**[Docket No. NHTSA–99–6160]**

## Federal Motor Vehicle Safety Standards; Child Restraint Systems; Child Restraint Anchorage Systems

**ACTION:** Final rule, response to petitions for reconsideration.

**Figure 1B**

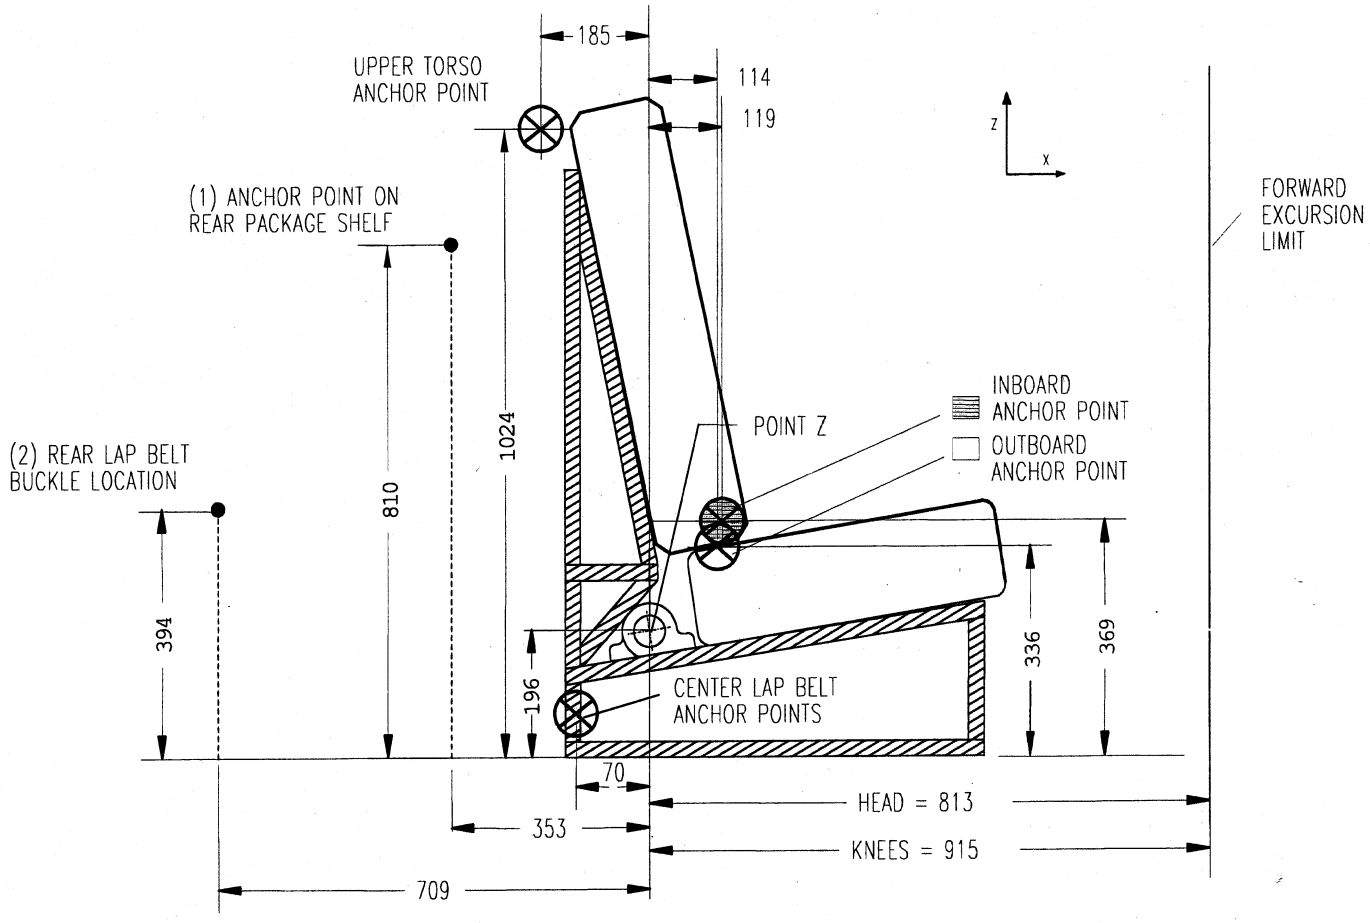
- Standard No. 213 is amended by correcting the table to S5.1.3.1(a) to show that backless booster seats are excluded from the new 720 mm head excursion limit. These seats were excluded because, as discussed in the preamble, the manufacturers of backless booster seats may have practicability problems in meeting the requirement. In addition, S5.9(a) of the standard is corrected to specify that for rear-facing child restraints with detachable bases, only the base need have the permanently attached components that enable the restraint to be securely fastened to the lower bars of a child restraint anchorages system (as opposed to requiring the components on both the base and the restraint system itself). The agency intended to specify this limitation in Standard No. 213 (see 64 FR at 10806–10807), but did not do so in the regulatory text of the final rule.

c. Figure 1B and Figure 1B′, as amended at 64 FR 10820, effective September 1, 1999, are revised.

Figure 1A - Child Restraint Fixture (CRF) with Side and Top Frames Removed

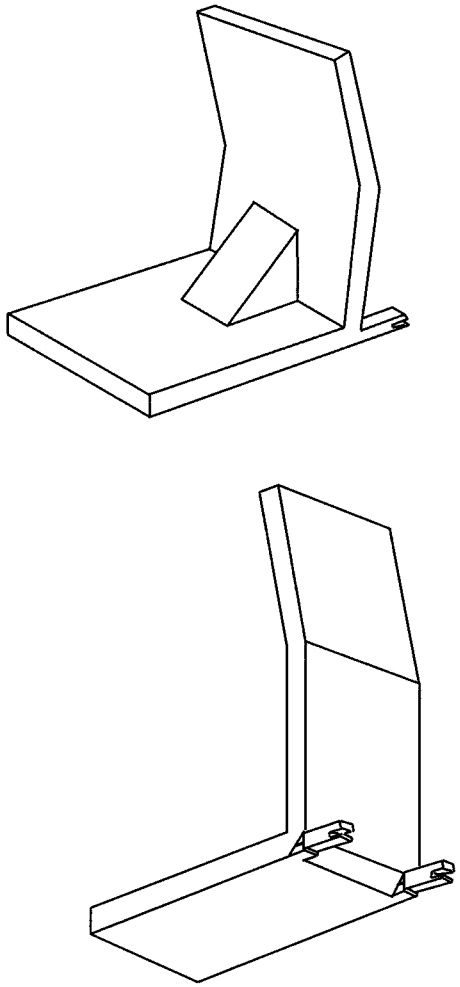
American Honda states in its petition that it can be very difficult or impossible to get the CRF into the rear seating area of some vehicles, such as small two-door cars. The commenter states that the draft ISO standard (which developed the CRF and the procedures for its use) specifies that ''To facilitate installation of the CRF in a vehicle seat, the CRF may be constructed of smaller parts and assembled in the vehicle seat. Alternatively, vehicle components maybe removed to allow access.'' Honda requests that similar language be added to Standard No. 225. Honda also states ''From a practical standpoint, we believe that child restraints will be offered in various sizes, including child restraints that are somewhat smaller than the CRF for use in small vehicles. * * * Thus, if the CRF, in its full shape and size, can be fitted to the lower anchorages, we believe it is not important whether the CRF had to be assembled in place or some vehicle components (e.g., front seat) had to be removed to facilitate getting the CRF into the seat position where the lower anchorage fit was being checked.''

n. Adding a Figure 1A between Figures 1 and 2.

(c) To facilitate installation of the CRF in a vehicle seat, the side, back and top frames of the CRF may be removed for installation in the vehicle, as indicated in Figure 1A of this standard.

**Figure 17- Side, Back and Bottom Views, ISO 13216-1 Static Force Application Device 2 (SFAD 2)**

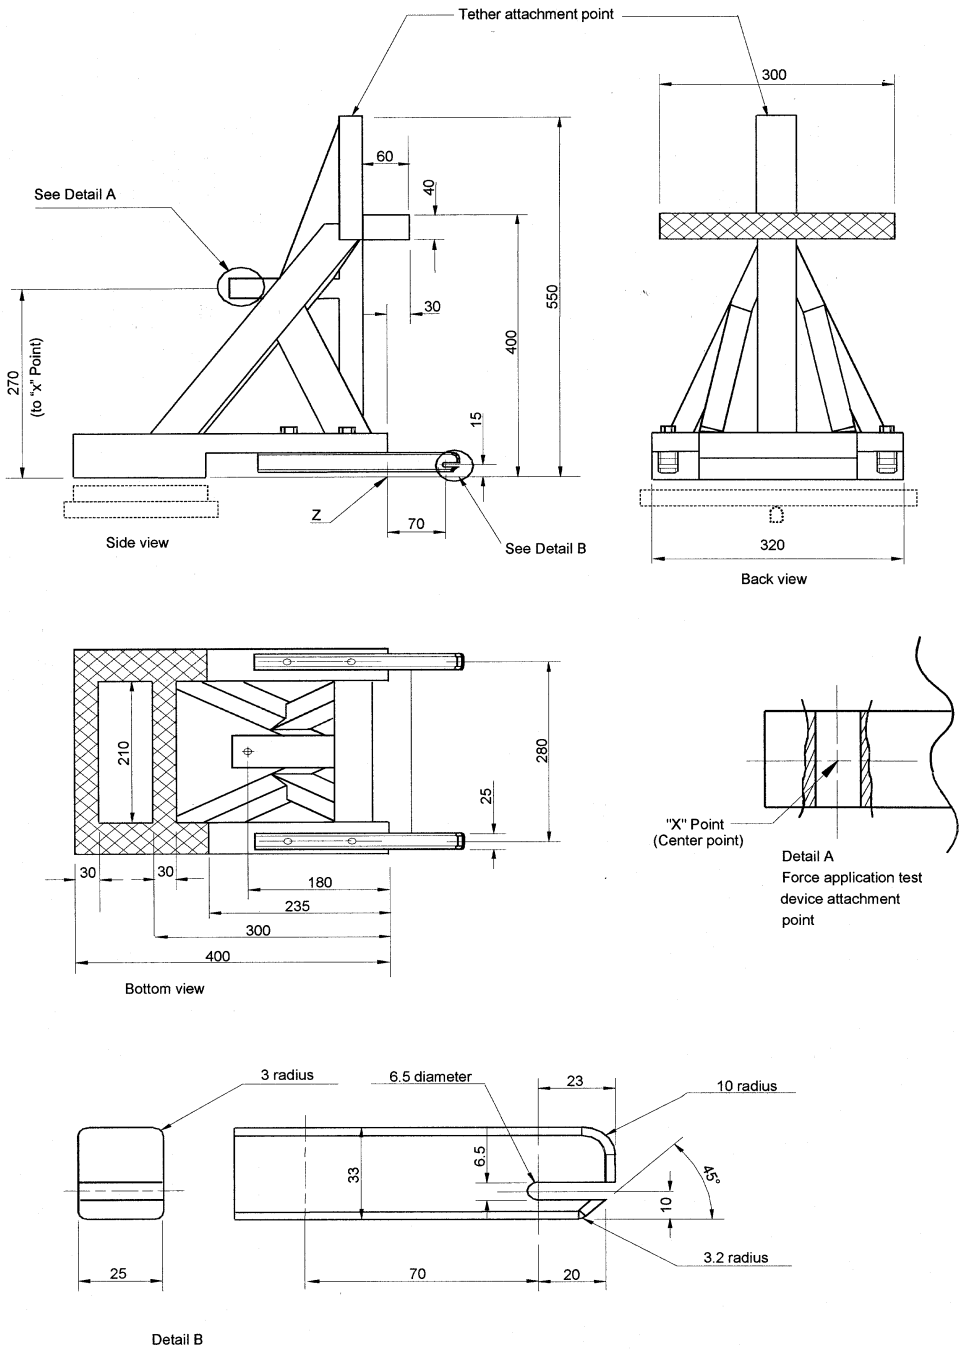
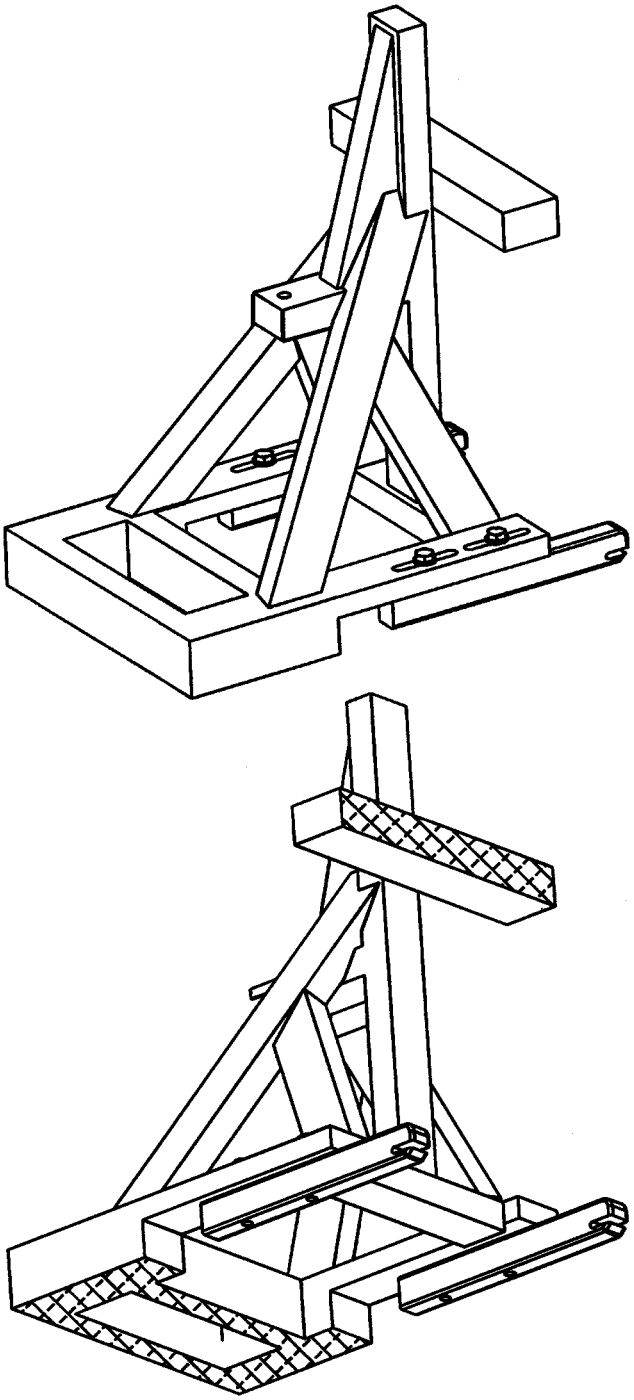
The Alliance suggests that the tether anchorage test procedure of S8.1(b) be amended by adding an instruction for adjusting the fore-aft position of the rear attaching bars of the test device used to test a tether anchor at a seating position with a child restraint anchorage system (the test device referred to as SFAD 2). We have added the suggested instruction to S8.1(b). Petitioner also suggests that the shape of the SFAD 2 attachments that contact the lower anchor bars be specified because the shape could affect the outcome of the test. We have modified Figure 17 of the standard to show in Detail B that the rear of the slot in the SFAD 2 connecting arms has a diameter of 6.5 mm. The petitioner also suggests that a stiffness specification for SFAD 2 be added as in the draft ISO standard, to ensure that the test fixture is sufficiently strong to withstand the forces in the test. We have added a stiffness specification, from the draft ISO standard, to Figure 17.

- S11(a) and (b) of Standard No. 225 are corrected by adding a 135 N rearward force to remove slack or tension to the device prior to its loading. The specified force is from the draft ISO standard.
- The following figures in Standard No. 225 are corrected: Figure 1 (added yaw/pitch/roll); Figure 2 (added mass of CRF and corrected dimensions on top view); Figures 3 to 11 (darkened shading); Figure 15 and 16 (corrected dimension that Transport Canada also has on top view); Figure 17 (added 6.5 mm diameter on detail B, deleted point Y on detail A, corrected 270 dimension on side view and added stiffness details to side and back views and to note 5); Figure 18 (made force application attachment as in Figure 17); and Figure 19 (degree sign).

**Figure 19 – Side View, Optional Tether Anchorage Test for Passenger Cars until September 1, 2004**

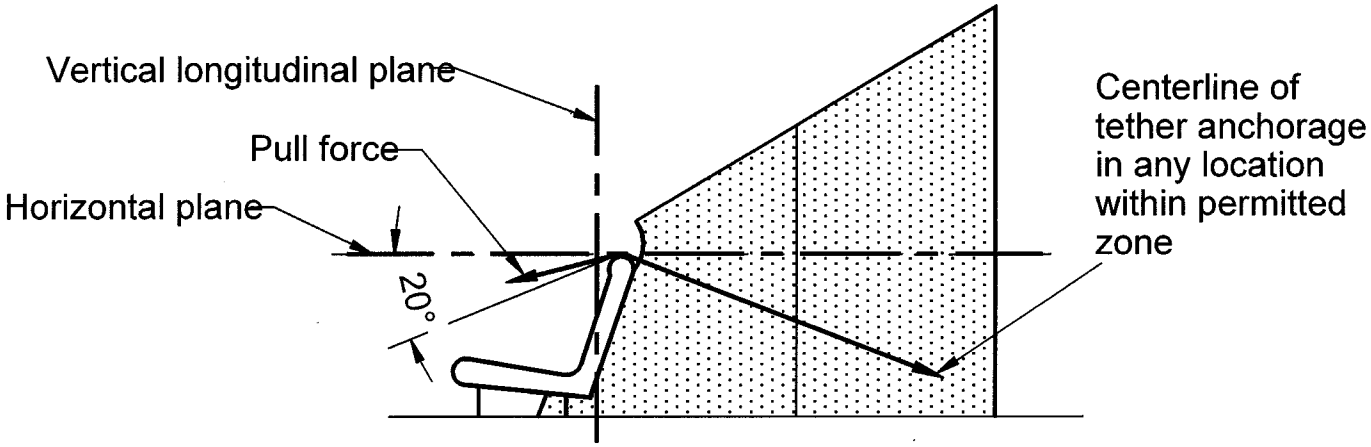
(3) passes over the top of the vehicle seat back as shown in Figure 19 of this standard;
